NAME INSTALLATION-FURN. ABK ANT. MAST & SUPPORT

CONSOLIDATED AIRCRAFT CORP. San Diego, Calif.

J 28F6450

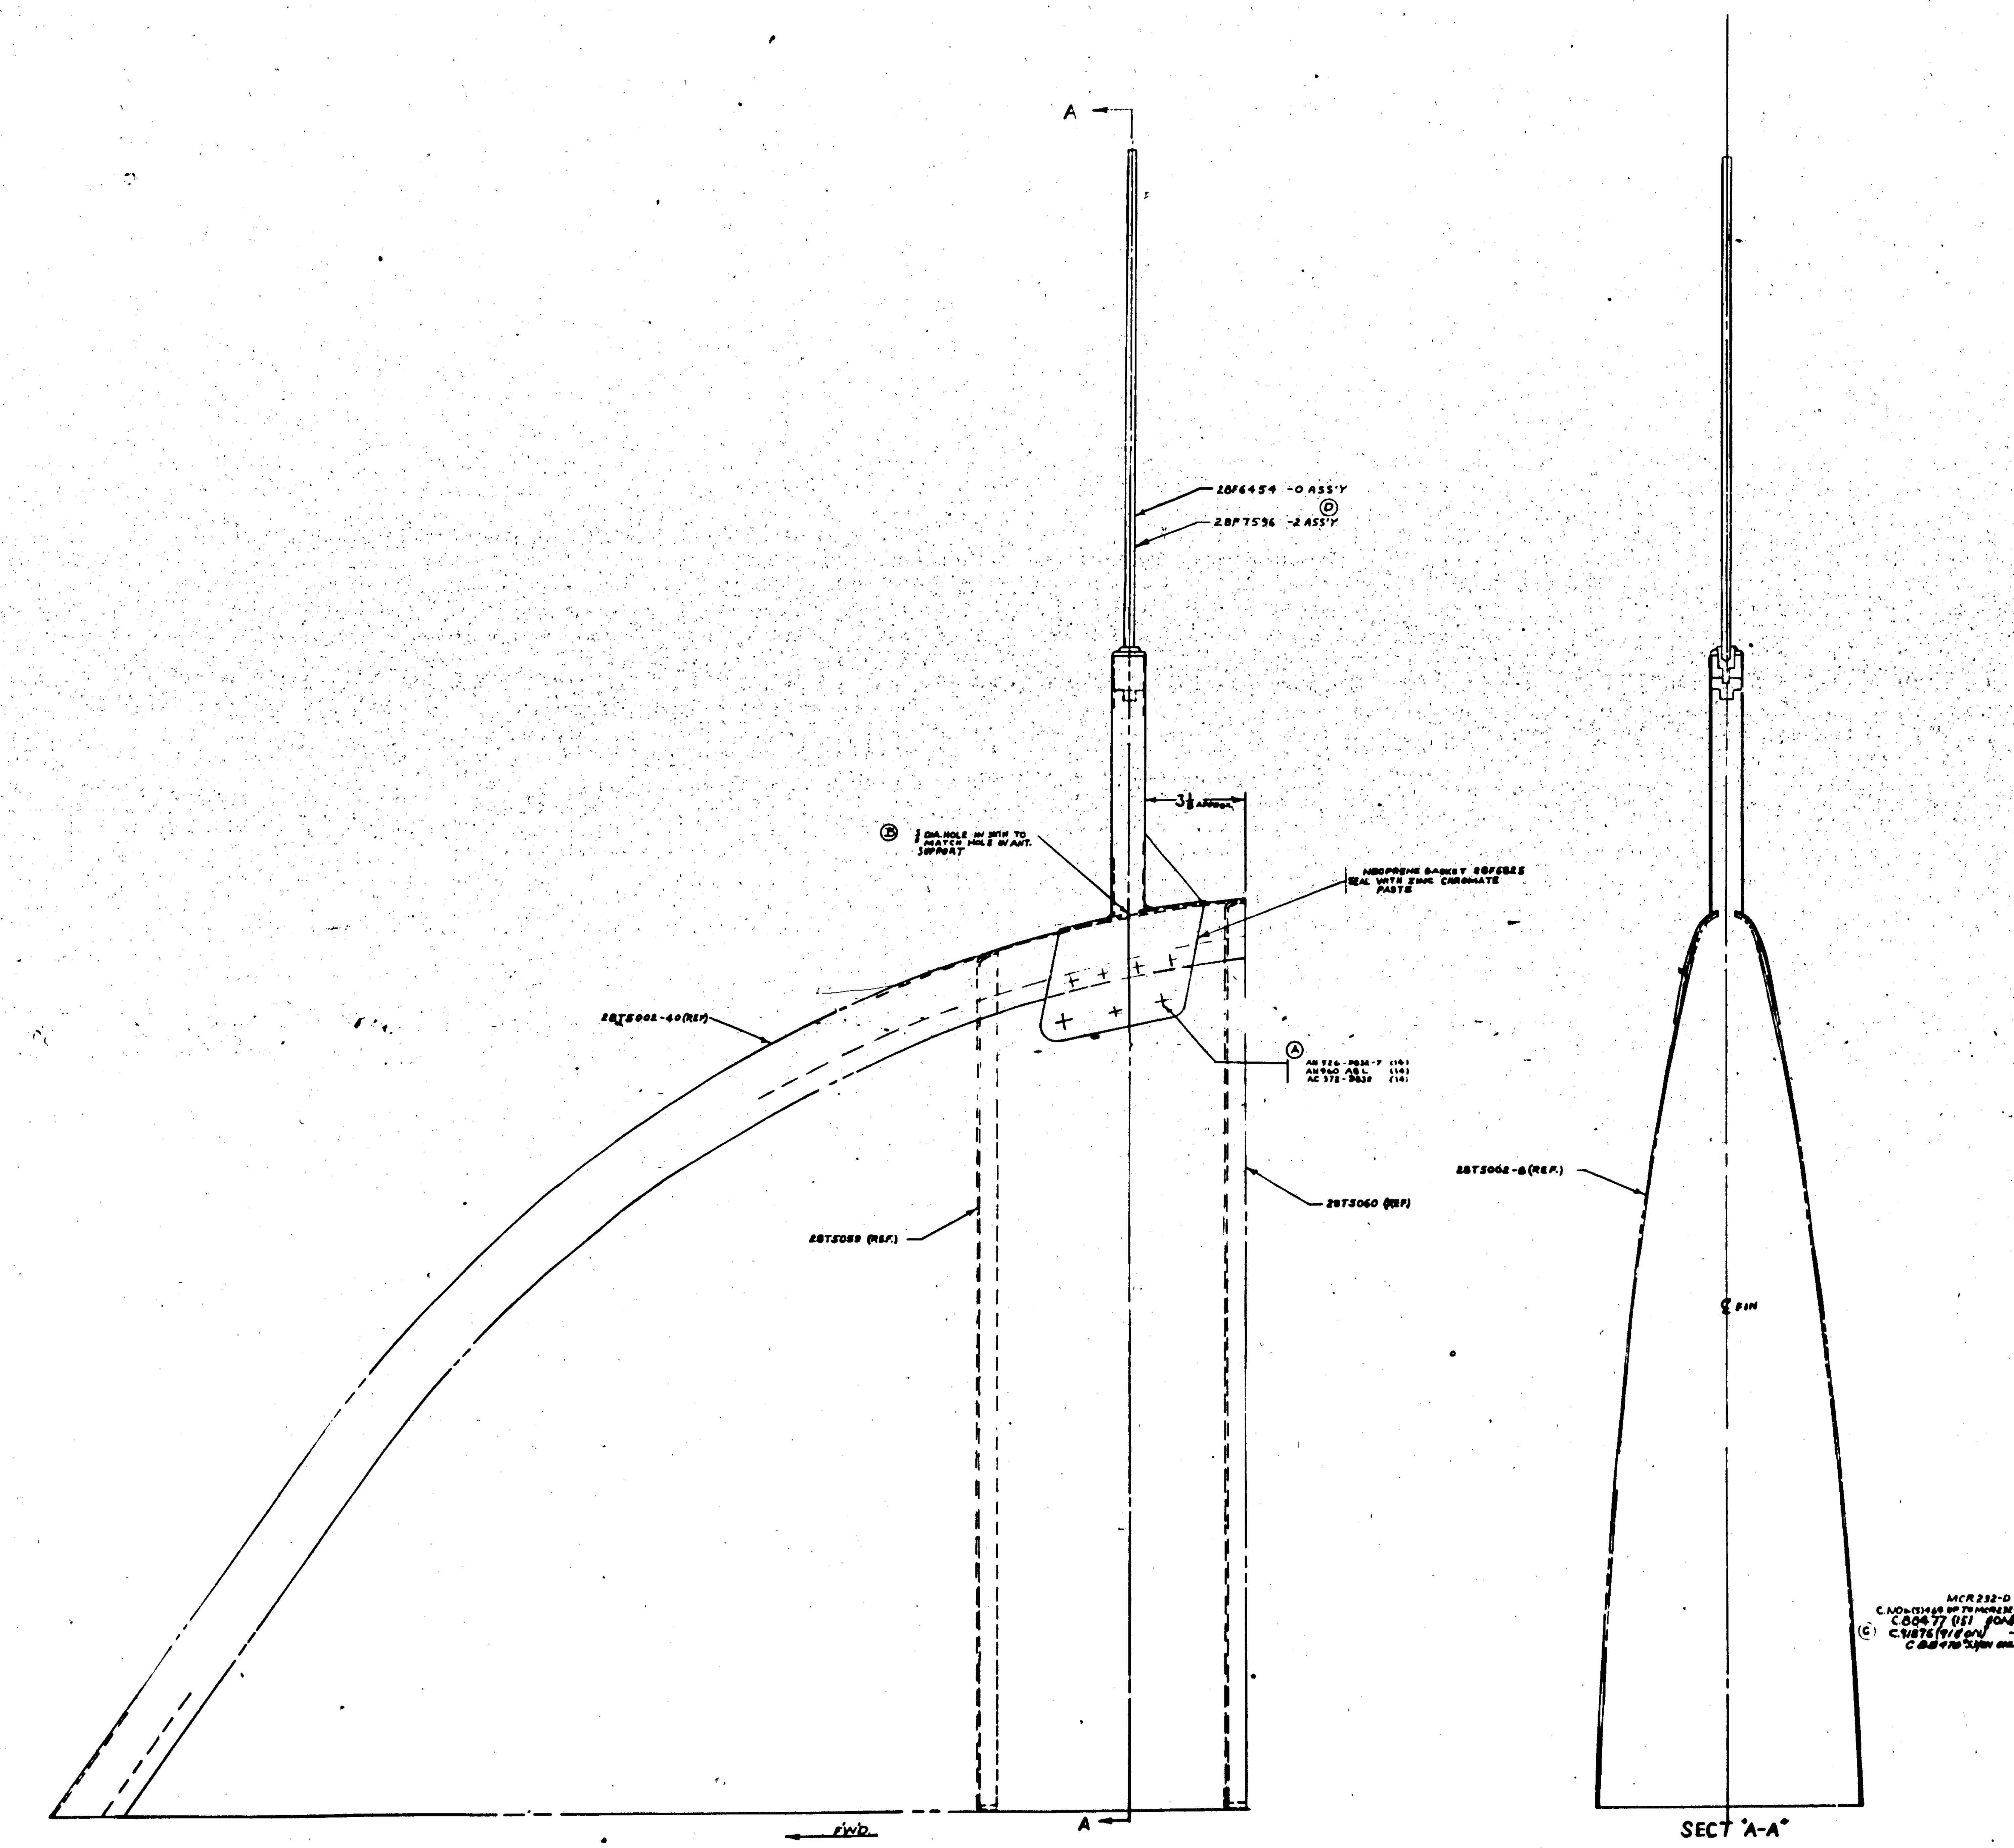
LET	ALTERATION	DATE	BY	LET	ALTERATION	DATE	BY
				A	AN526-D832-7(14), AN960A8L (14) & AC372-D832(14) REPLACE D4308-D4(4)(WT. CHG. NEG.)	4-3-4?	
				B	1/8 DIA HOLE(1) WAS 1/2 DIA. HOLE(1) (NEG. WT. CHG.)	12-4?	
				C	[illegible]	6-1-4?	
				D	CREATED -2 ASS'Y. TO FACE ADDED 28F7596 -2 ASS'Y. LIMITED REFERENCE TO -0 ASS'Y. IN REQ. BLK. ADDED -2, PBY-5A 28F6002(1) & LIMITED TO MCR232-D. LIMITATION "C. NO. [illegible] UP TO MCR 232-D" WAS "C. NO. [illegible]" FOR -0 PBY-5A N/A 28F6002. WT. .74 FOR -0 ASSY. WAS .96. ADDED WT. .77 FOR -2 ASSY	6-?-4?
